**ENVIRONMENTAL COMMISSION MOTION 20191106 008a**

**Subject:** 3801 Westlake Drive, SP-2019-0243DS (District 10)

**ITEM FOR ENVIRONMENTAL COMMISSION AGENDA**

**REQUEST:** Variance request is as follows:  
Request to vary from LDC 25-8-281(C)(2)(b) to allow construction  
of a boat dock and shoreline access within a 150-foot Critical  
Environmental Feature (CEF) buffer for a Rimrock CEF.

## PROPOSED SITE PLAN

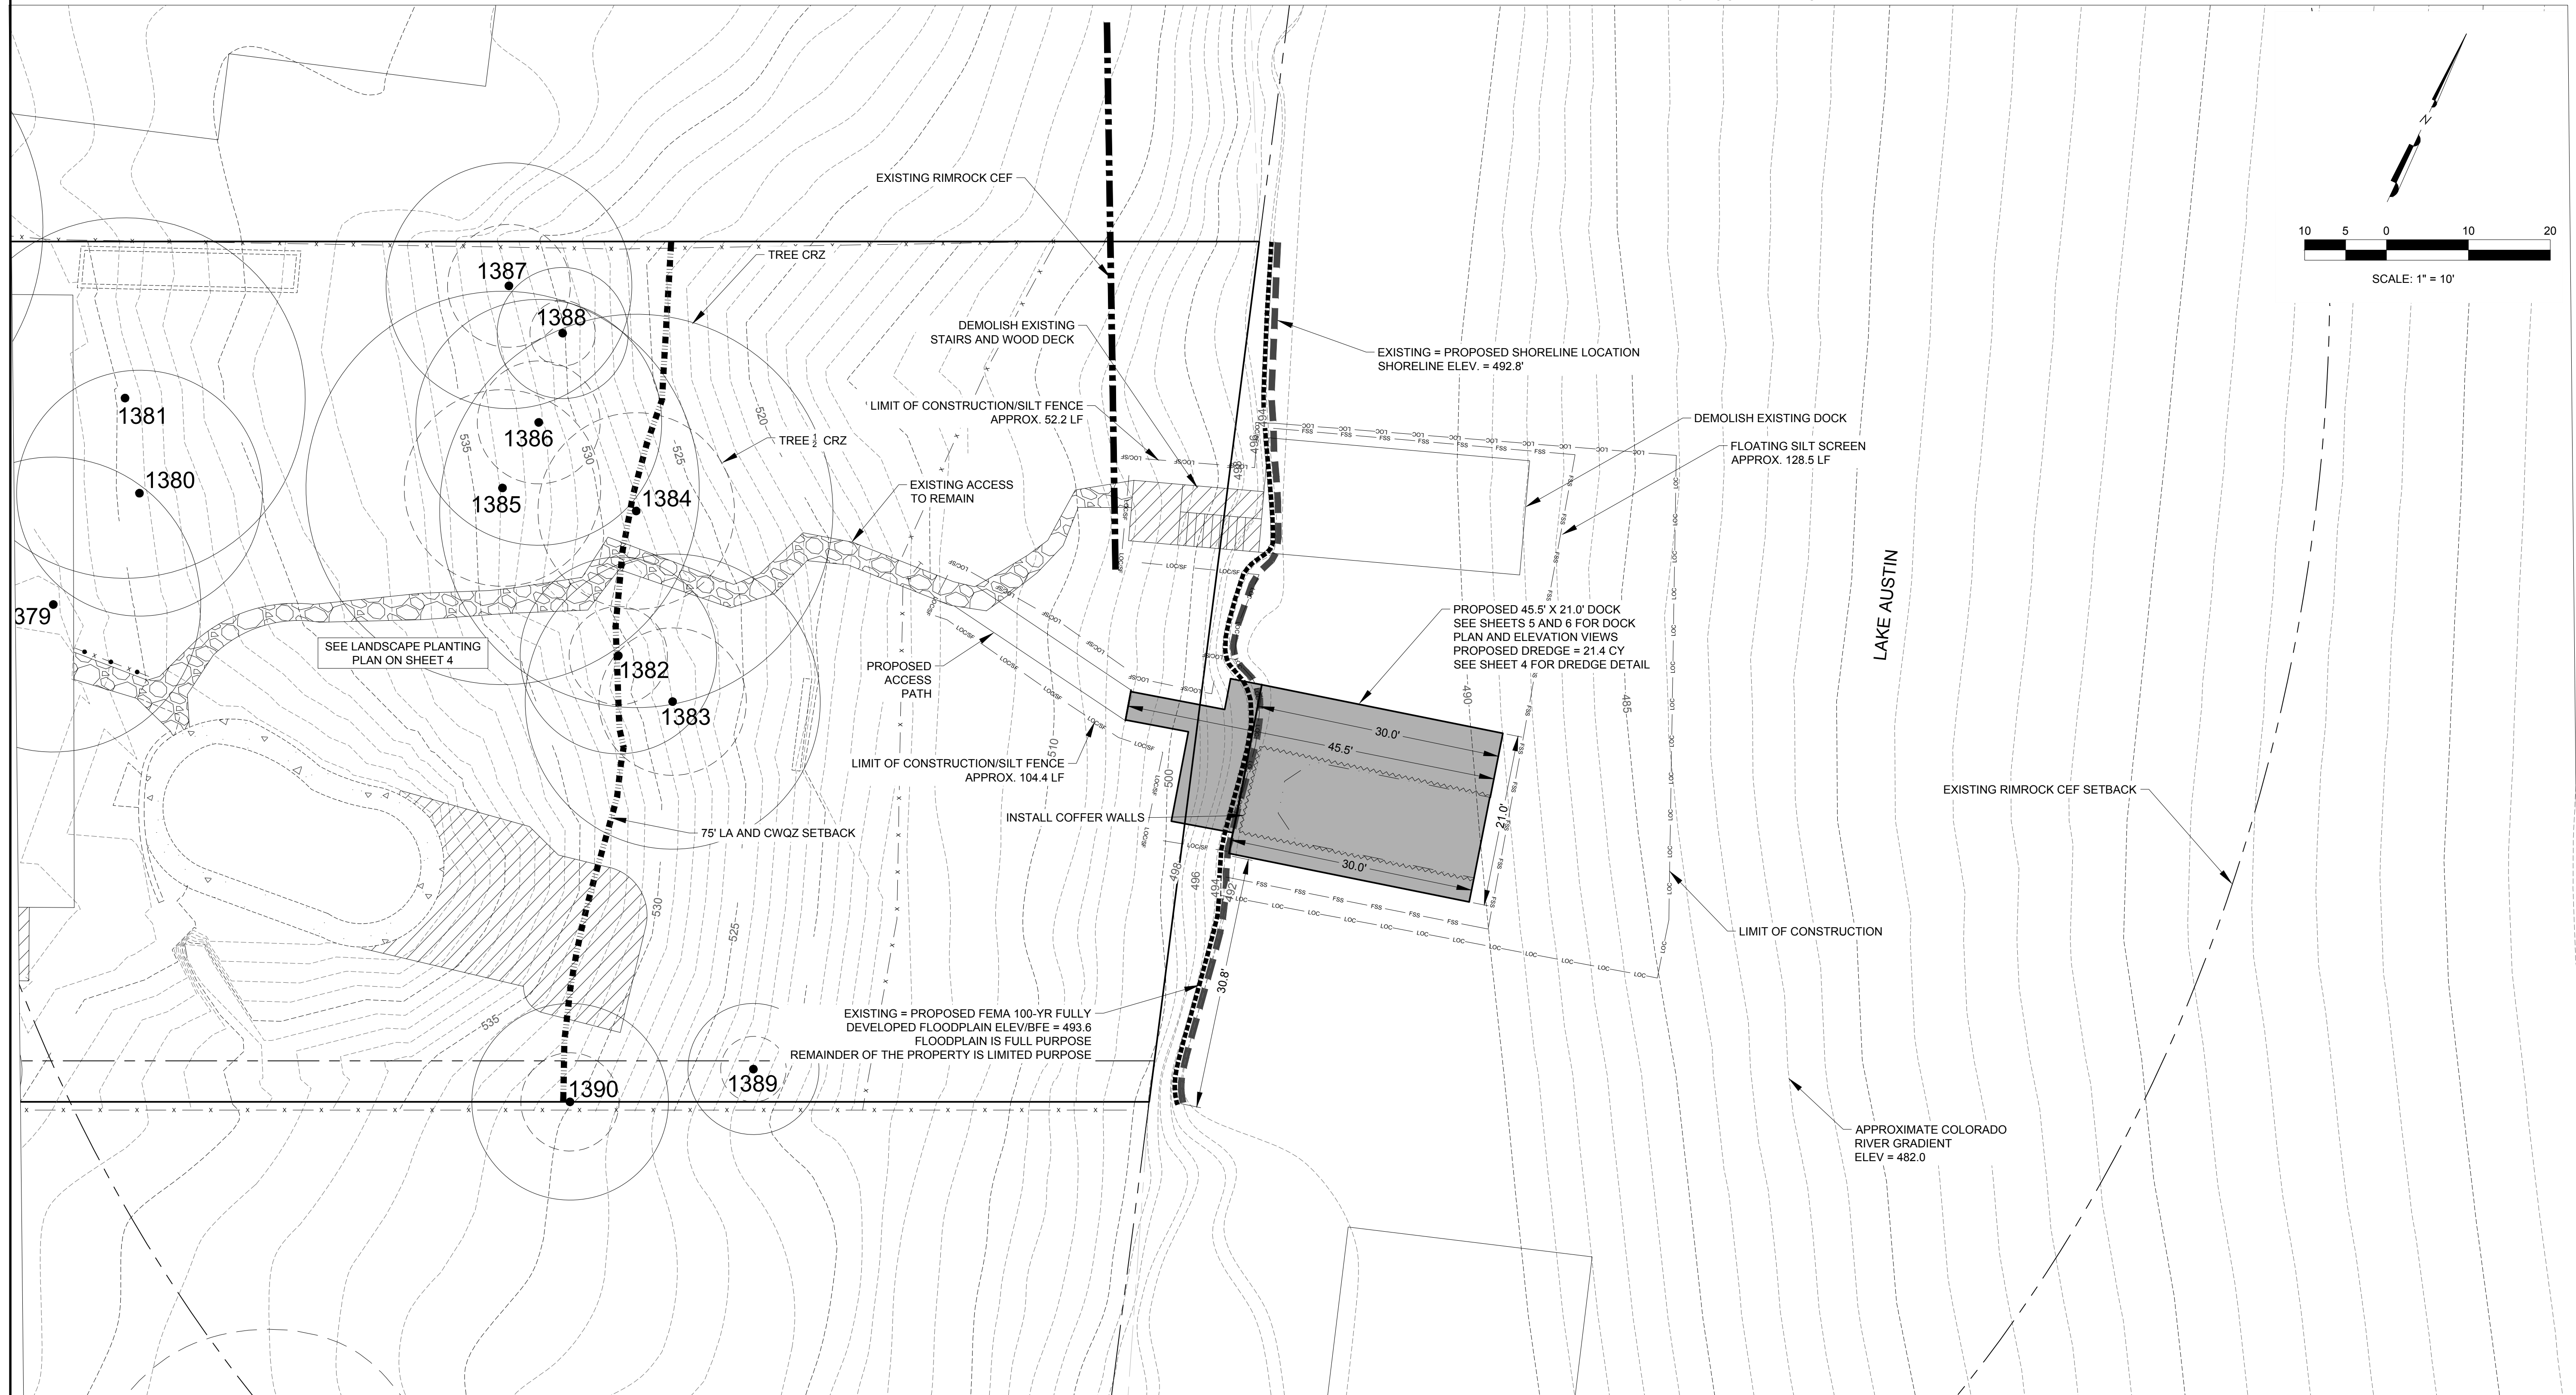
1. The portion of the existing access path that will be bypassed, between the point where the new path will branch off from the existing path and the endpoint of the current path where it connects with the current bridge, shall be removed and revegetated.
2. In the plan set, a non-erodible surface (e.g., paving, shallow stairs, etc.) for the proposed path shall be specified.

1. The owner comply with boat dock registration process after the completion of the improvements consistent with the Lake Patrol requirements for Lake Austin boat docks.
2. The existing dock demolition and new dock construction be completed by water borne barge and not via the site.
